KEELER DUNES DUST CONTROL PROJECT

FINAL ENVIRONMENTAL IMPACT REPORT /
ENVIRONMENTAL ASSESSMENT

VOLUME IV

10.0	CLARIFICATIONS AND REVISIONS TO THE DRAFT ENVIRONMENTAL IMPACT REPORT / ENVIRONMENTAL ASSESSMENT	10-1
11.0	RESPONSE TO COMMENTS ON THE DRAFT ENVIRONMENTAL IMPACT REPORT / ENVIRONMENTAL ASSESSMENT	11-1
11.1	Summary Distribution List/Respondents.....	11-1
	11.1.1 Federal Agencies	11-1
	11.1.2 State Agencies	11-2
	11.1.3 Regional or Local Agencies.....	11-2
	11.1.4 Native American Tribes	11-2
	11.1.5 Individuals or Private Organizations	11-3
11.1	Letters of Comment and Responses.....	11-3
	11.2.1 Federal Agencies	11-4
	11.2.2 State Agencies	11-5
	11.2.3 Regional or Local Agencies.....	11-12
	11.2.4 Native American Tribes	11-22
	11.2.5 Individuals or Private Organizations	11-27

FIGURE 3.8.2.2-2
 Springs in Study Area Vicinity

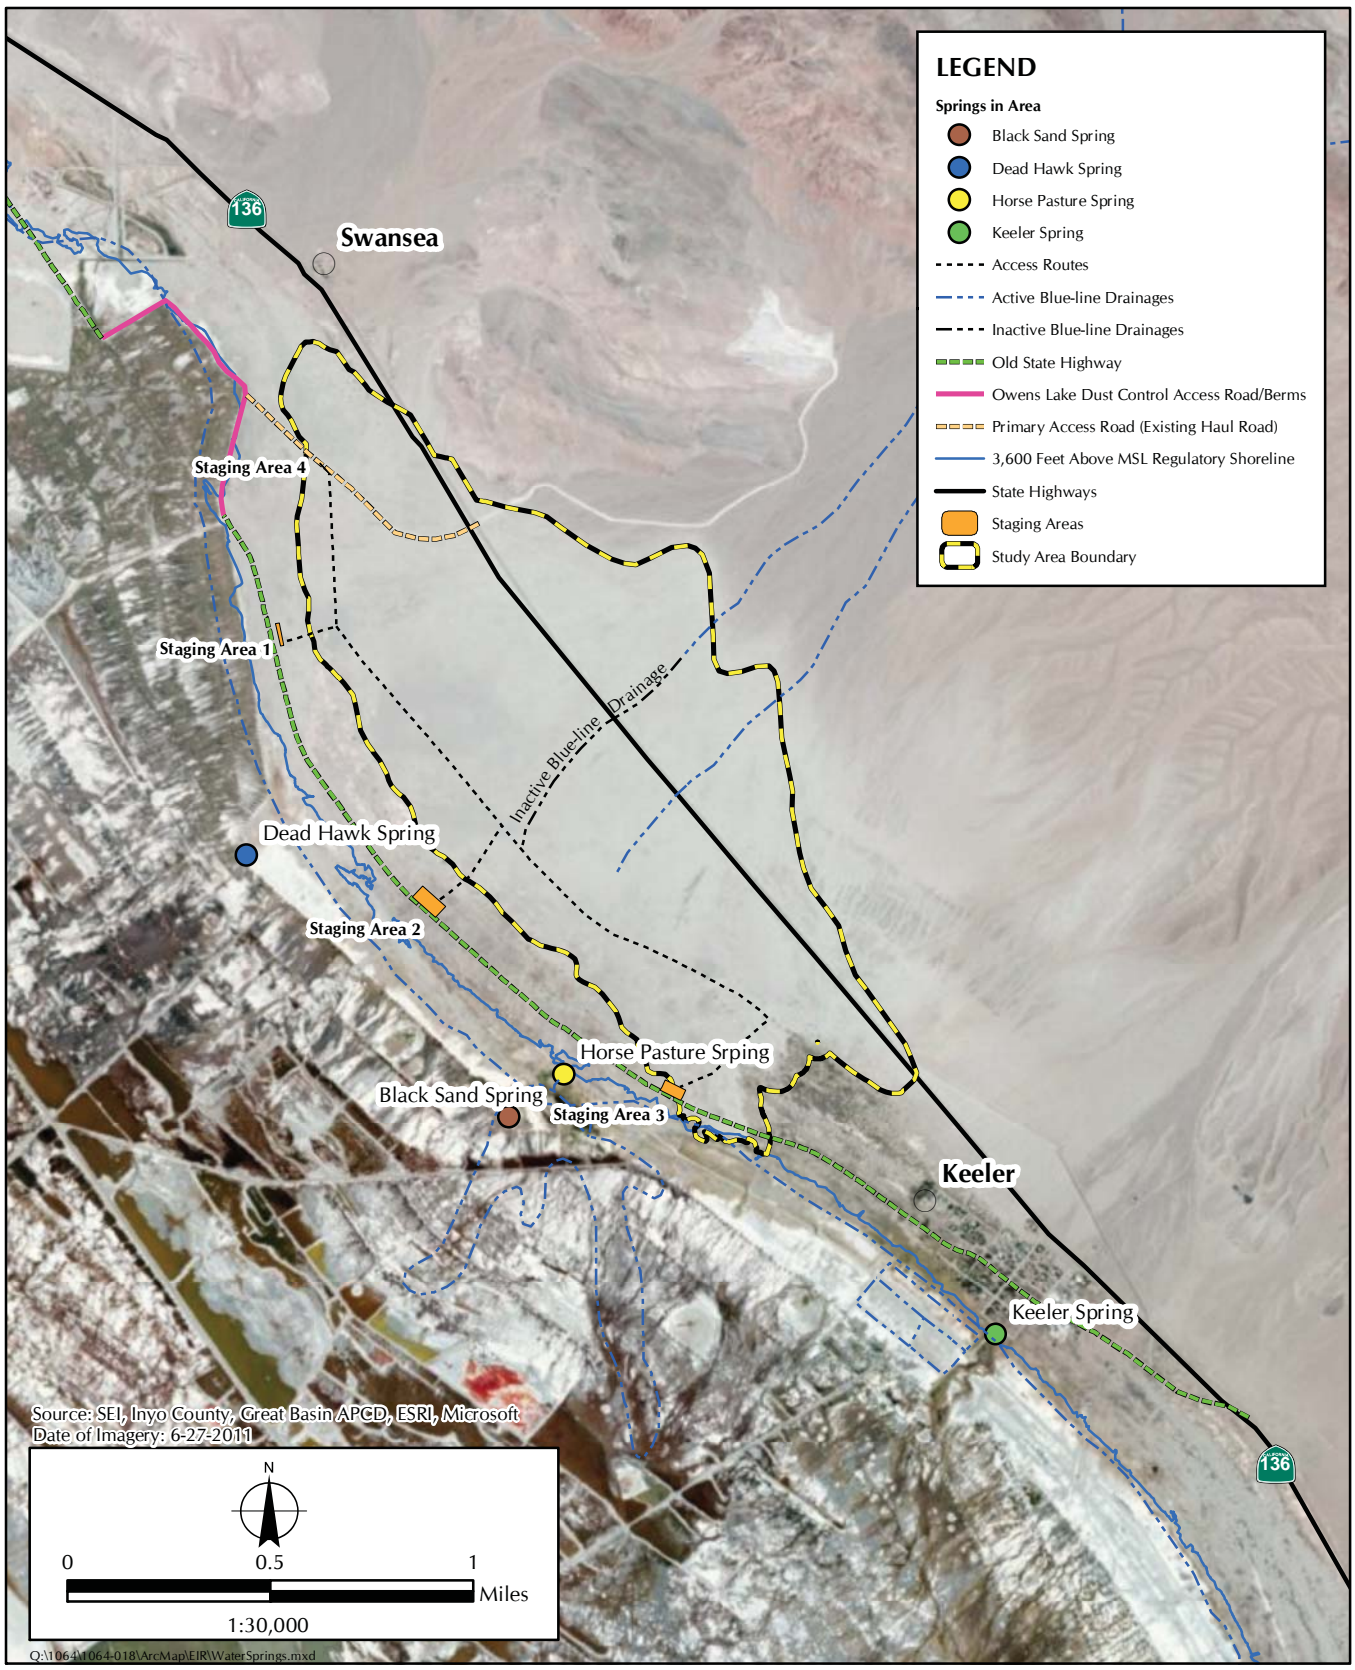
Page 3.8-8, paragraph 2: Add language about the presence of the Dead Hawk Spring into the text. This is a spring mound located on the northeast portion of Owens Lake bed near the project area. It is a natural feature and not created by an abandoned artesian well. | 11

Figure 3.8.2.2-2: Add location of Dead Hawk Spring to map. | 12

Page 3.8-7 Figure 3.8.2.2-2, *Springs in Study Area Vicinity*, following this page, has been revised to show the location of the Dead Hawk Spring.

Please see clarifications and revisions to Figure 3.8.2.2-2.
